Final Technical Review (CESIR)

**5932 Monks Road
Canadaigua, NY 14424**

File # 11446

Prepared By: (LaBella)
Reviewed By: MAC
Date: May 8, 2017

1. Voltage-Frequency

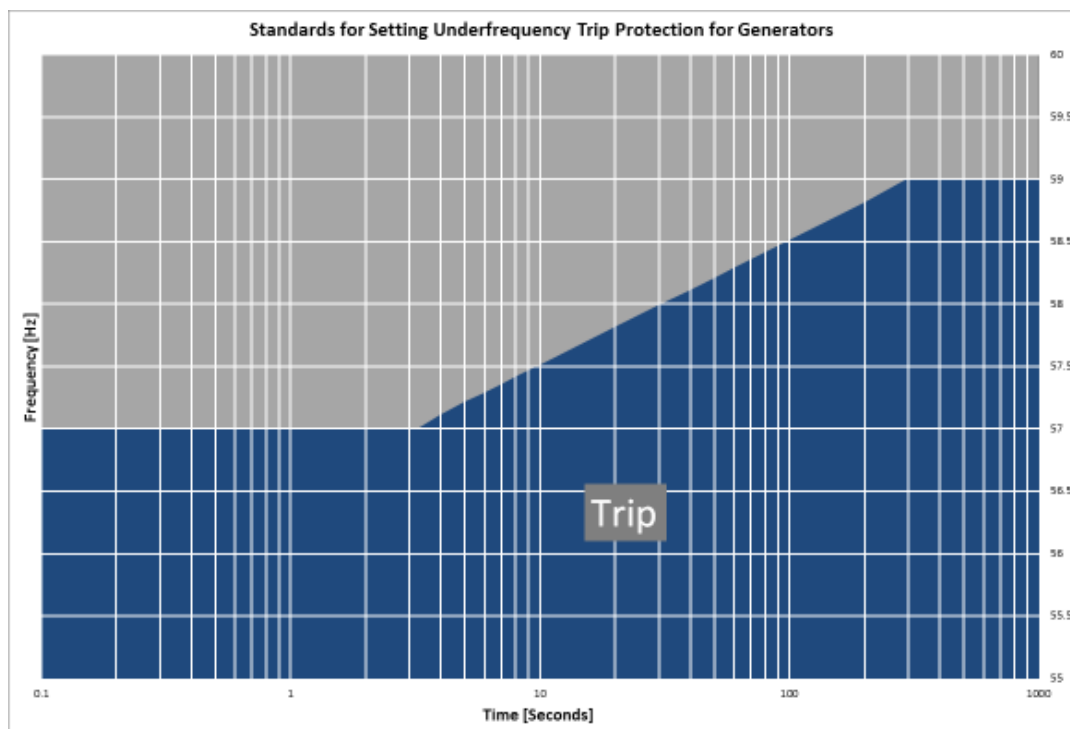
The proposed voltage and frequency settings for the inverters are NOT provided. The settings need to be as follows:

<u>Voltage (% of Rated)</u>	<u>Clearing Time (s)</u>
$V < 50$	0.16
$50 \leq V < 88$	2.00
$110 \leq V < 120$	1.00
$V \geq 120$	0.16

The Customer will need to provide these to RGE for review and approval.
